**RE: Lead Ave. SW Condominiums
Grading Plan
Stamp Date: 1/9/17
Hydrology File: K13D075**

Based upon the information provided in your submittal received 3/28/2017, the Grading Plan **is not** approved for Building Permit. The following comments need to be addressed for approval of the above referenced project:

GRADING AND DRAINAGE
LEAD AVE. SW
CONDOMINIUMS
ALBUQUERQUE, NEW MEXICO

SHEET CI-1

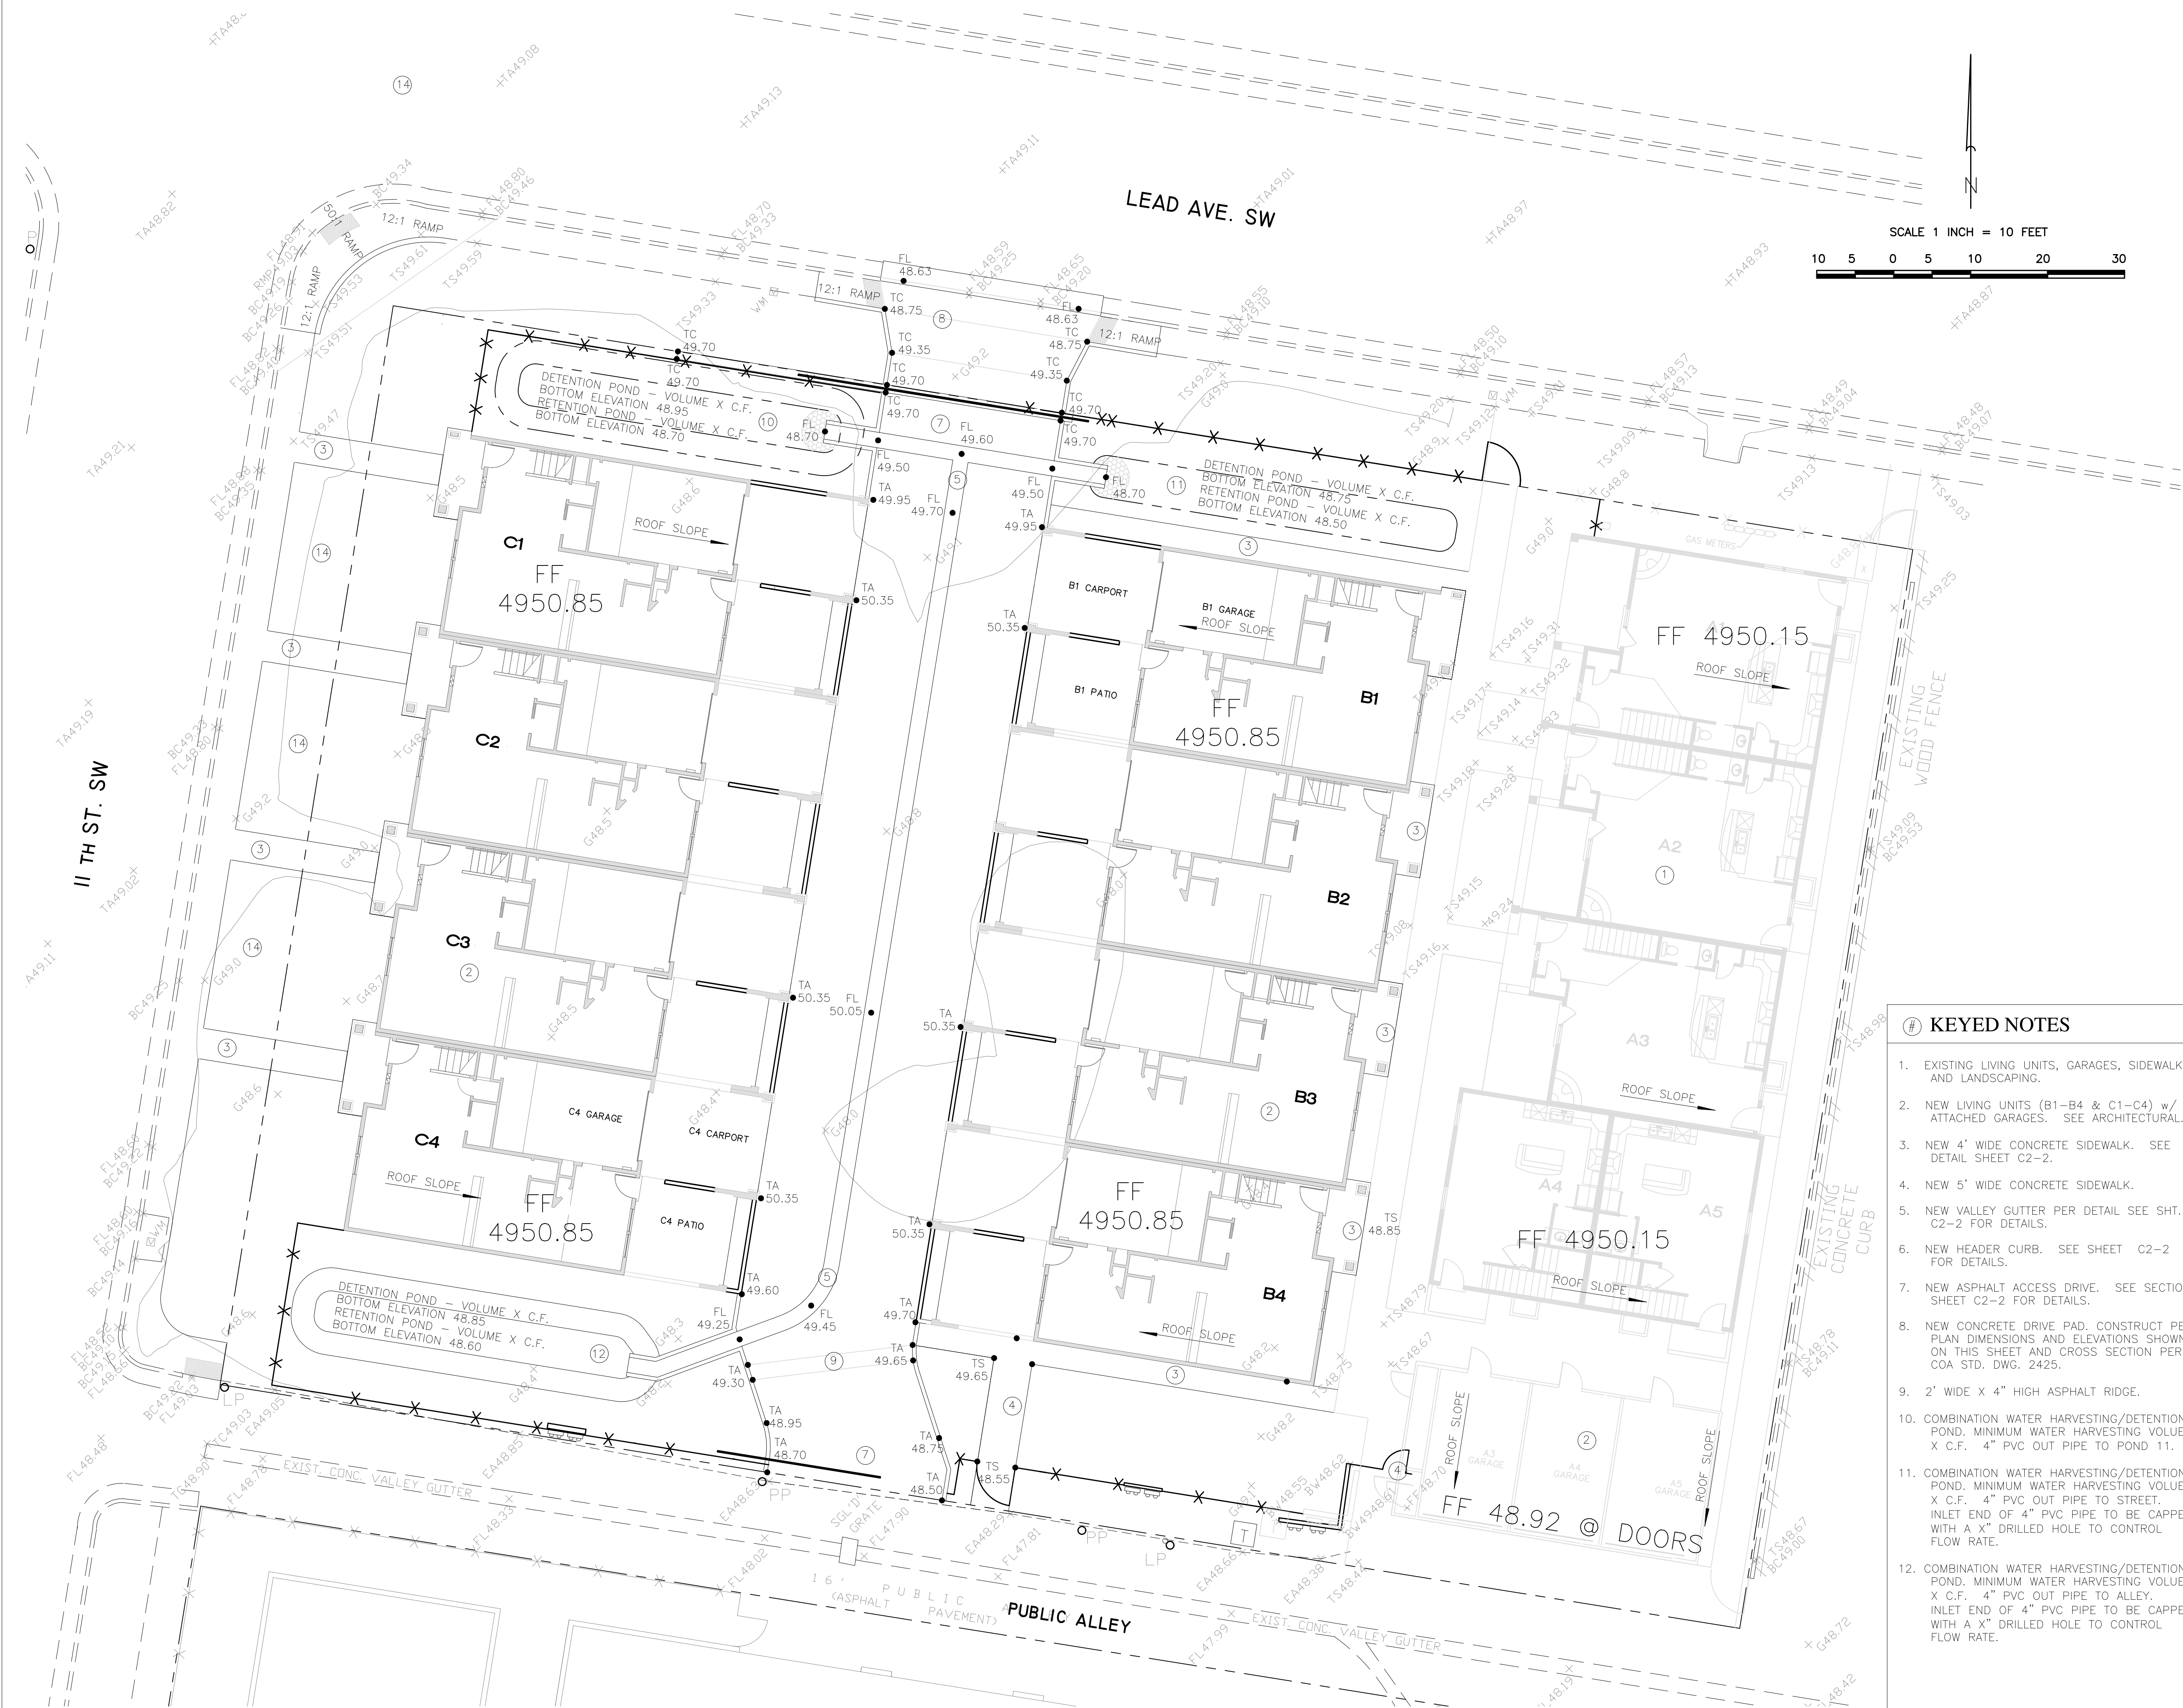
1. On Sheet C1-1. Please provide the vicinity map and the FIRM map.
2. On Sheet C1-1. In Keyed Notes #10, 11, & 12, there is a 4" pvc called out. This 4" pvc is not shown on the plans. Please also provide the flow lines of the pipe.

3. On Sheet C1-1. In Keyed Notes #11 & 12, there is a reference to a x" drilled hole to control the flow. Please provide the size of the drilled hole and the calculations that support each of the outfalls. Please show the control rate of flow at each of the outfalls.

4. On Sheet C1-1. Please show the volume of the detention provided and the volume of retention provided for each of the three ponds.
5. On Sheet C1-2. For the existing site drainage calculations, the existing treatment is not all "A" but a mixture of "B", "C", and "D". Please correct the calculations. Also this should be in maybe two different drainage basins. This way it is easier to follow that Basin A (for the existing Condo) is free discharge into Lead Ave.
